**BLOCK 21** Full Alley Vacation Proposal

Second Early Design Guidance  
January 20, 2015

2200 7th Ave, DPD #3018578

EDG1 Site Plan

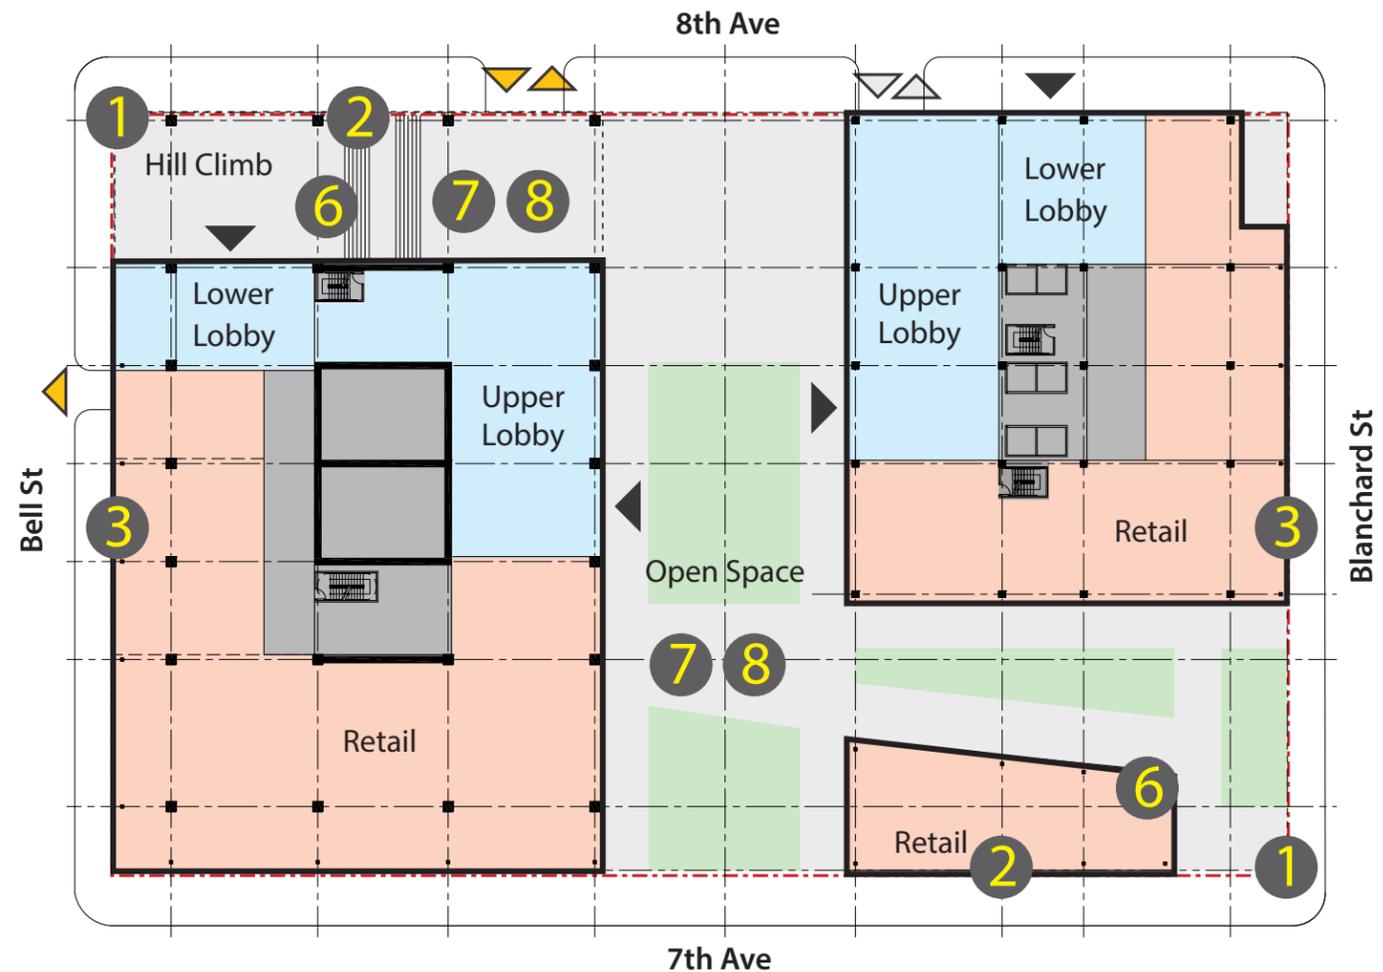
- 1 Provide better open space that is easily accessed.
- 2 Engage with the street; design a porous street edge.
- 3 All open space should be accessible at grade.
- 4 Setback the structures along Bell and Blanchard streets.
- 5 Provide modulation and articulation of the tower. Redesign to be better proportioned using modulation, façade treatment and/or a tower size similar to Option 2.
- 6 Avoid office uses along the street facing level.
- 7 Retail and open space should relate to each other.
- 8 Provide open space and retail space along Bell and Blanchard.

- 1 Eliminate retail pavilion and expand grade-level open space along Seventh Avenue
- 2 Consolidate vehicular entries and expand extent of accessible open space along Eighth Avenue
- 3 Voluntarily set back north and south buildings 10' along Blanchard and Bell Streets.
- 4 Provide fully ADA accessible route at through-block connection
- 5 Provide active ground-level frontages at Blanchard and Bell Streets
- 6 Limit ground-level uses to retail and building entries in lieu of office use.
- 7 Shape podium and tower to provide further modulation and articulation
- 8 Utilize massing, materiality and detailing to relate facade design to building uses
